# Access Compliance Report

## Public Rights-of-Way

Intersection ID: 27200	Main Street: ANNALEXA_LN	Cross Street: BALLANTYNE_COMMONS_PY	Location: NW
ADA ID: 782432D809B2	Ramp Type: Perp	Initial Pass/Fail: Fail	Overall Compliance: No
		Severity Score: 12.5

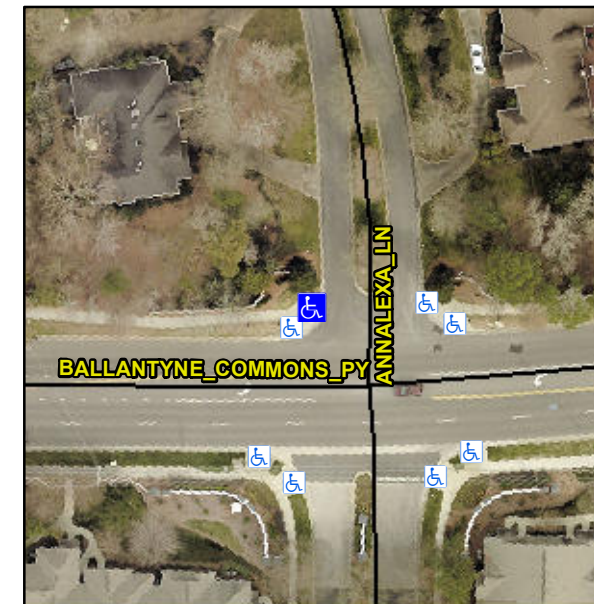
**Not Found, R304.2.2**

Compliance	Description	Data	Compliance	Description	Data
N/A	Ramp Length (in)	80.0	No	Ramp Slope (%)	9.3
Yes	Ramp Width (in)	48.0	Yes	Ramp XSlope (%)	0.9
N/A	Flare Type LT	N/A	N/A	Flare Type RT	N/A
N/A	Flare Slope LT (%)	N/A	N/A	Flare Slope RT (%)	N/A
N/A	Flare Traversable LT?	N/A	N/A	Flare Traversable RT?	N/A
N/A	Landing Length (in)	N/A	N/A	DWS Provided?	N/A
N/A	Landing Width (in)	N/A	N/A	DWS Contrast?	N/A
N/A	Landing Slope (%)	N/A	N/A	DWS Length (in)	N/A
N/A	Landing X Slope (%)	N/A	N/A	DWS Full Width?	N/A
N/A	Landing Curb? (Y/N)	N/A	N/A	DWS Offset (in)	N/A
N/A	Shared Landing?	N/A			
N/A	Gutter Ponding?	N/A	N/A	Gutter Slope (%)	N/A
N/A	Gutter Lip Ht (in)	N/A	N/A	Gutter X Slope (%)	N/A
N/A	Painted X Walk1?	No	N/A	Painted X Walk2?	N/A
	X Walk 1 Direction	To SE		X Walk 2 Direction	N/A
N/A	X Walk 1 Width (in)	N/A	N/A	X Walk 2 Width (in)	N/A
	X Walk 1 Slope (%)	1.6		X Walk 2 Slope (%)	N/A
	X Walk 1 X Slope (%)	0.9		X Walk 2 X Slope (%)	N/A

**Remove & Replace Entire Ramp.**
